TONE RINGERS No. 2B OR No. 5A
 IN TELEPHONES No. 722
 PROVISION OF "CUT-OFF" FACILITY

Post Office Telecomms. Headquarters Mk 1.2.2.3. Paper W Circulation GENERAL	ISSUES		
		L.R. Janyy.	15-8-68

TONE RINGER 2B
 FIG. 1

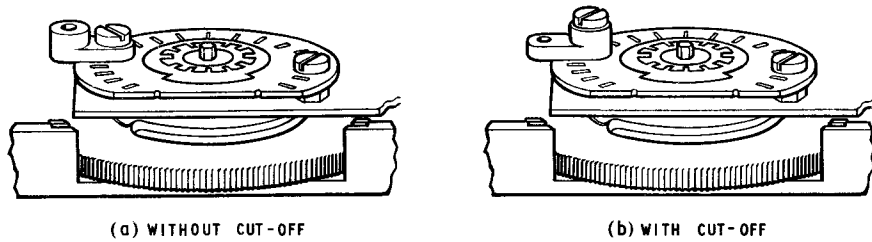
1. As issued the ringers are without the cut-off facility.
2. To provide the cut-off facility:-
 - Remove telephone cover.
 - Remove stop screw shown in Figs. 1(a) or 2(a).
 - Replace stop screw as shown in Figs. 1(b) or 2(b).
 - Replace telephone cover.
